Product Change Notification (PCN)

PCN #: 2F-2025

Date: March 04, 2025

453-00171R/453-00171C/453-00172R/453-00172C

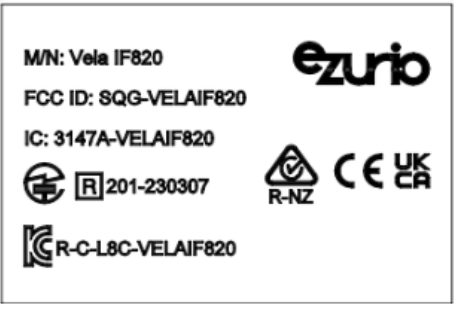
- 453-00171R/453-00171C On the PCB, update revision silkscreen from R1.0 to R1.1
- On the device laser-etching, update product revision from Rev 2 to Rev 3

453-00171R/453-00171C/453-00172R/453-0172C

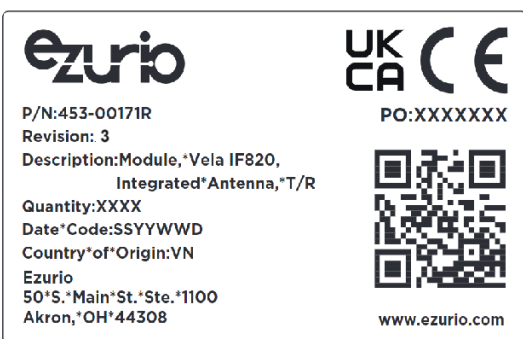
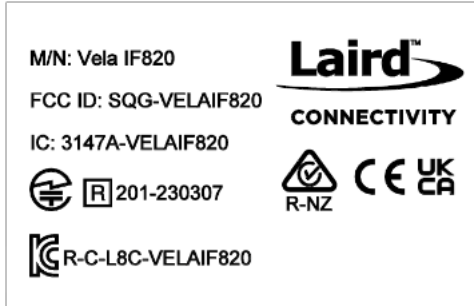
- On the shipping carton label,
 - o Update product revision from Revision 2 to Revision 3
 - o Replace Laird Connectivity logo with Ezurio logo
 - o Replace Laird Connectivity company name with Ezurio company name
 - o Change the placement from the diagonal to the adjacent side

453-00171-K1/453-00172-K1

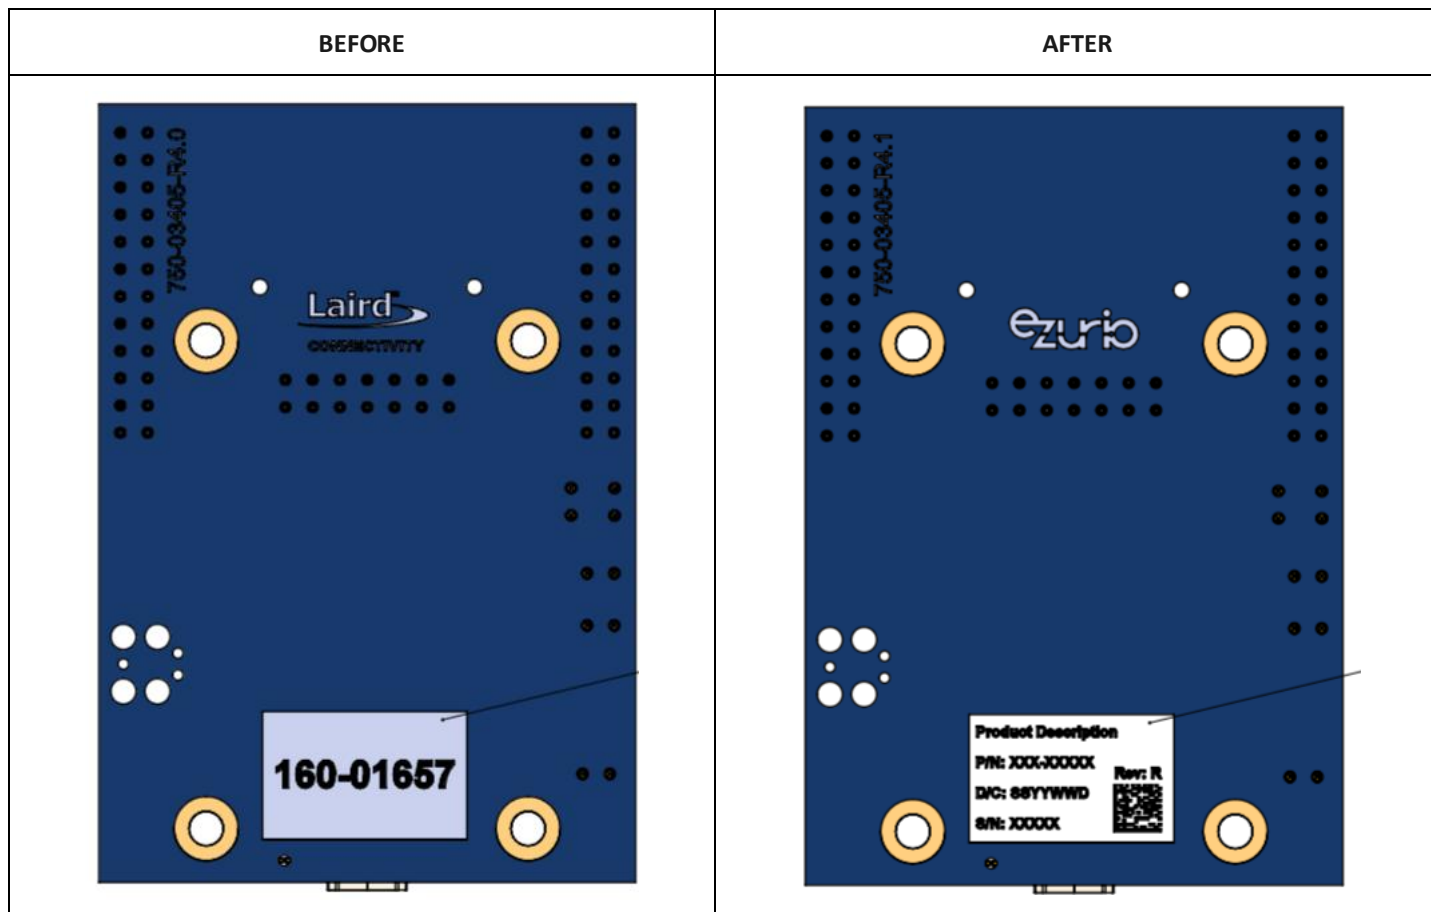
- On the Dev Board PCB, update revision silkscreen from R4.0 to R4.1

450-00185

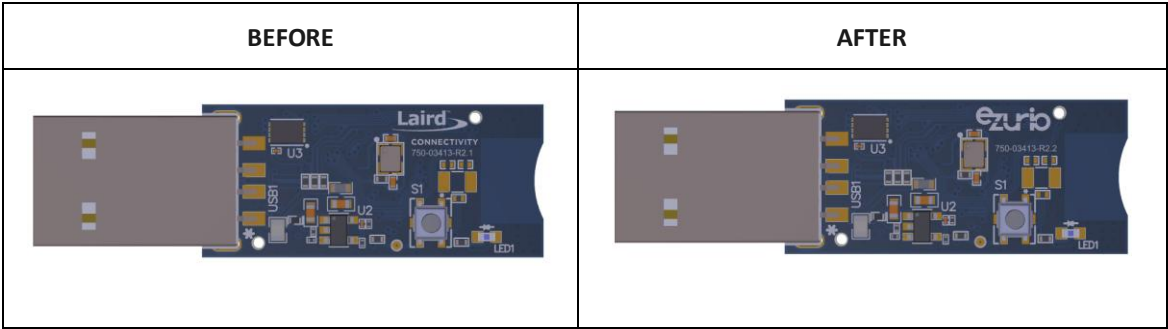
- On the PCB, update revision silkscreen from R2.1 to R2.2
- On the PCB, update logo from Laird Connectivity to Ezurio

450-00185

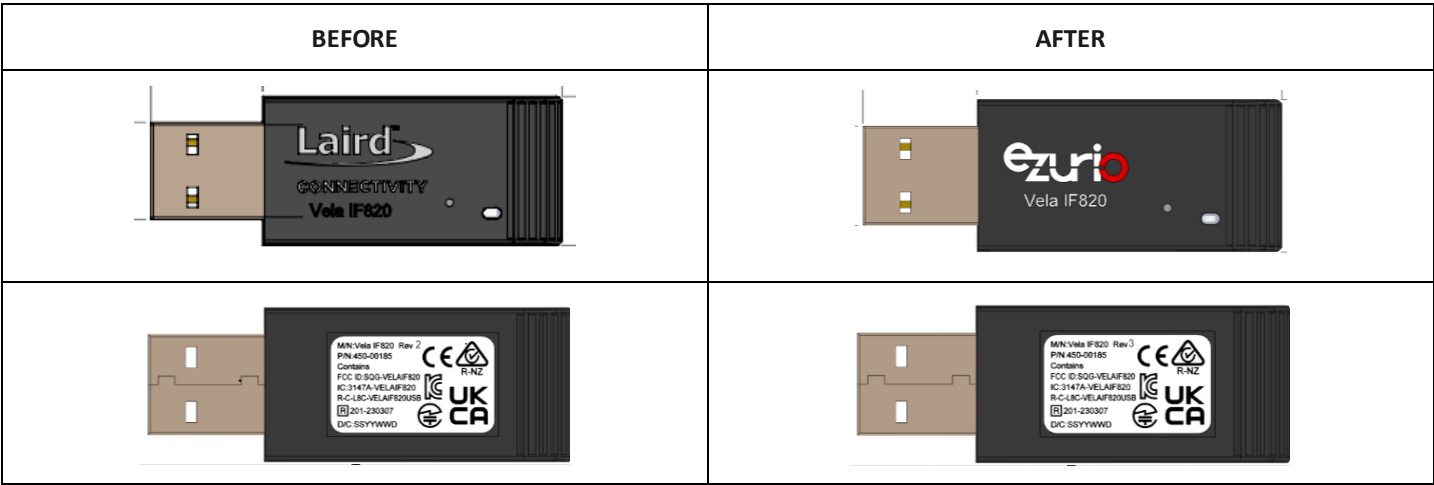
- On the product device logo from Laird Connectivity to Ezurio
- On the product device label from Rev 2 to Rev 3
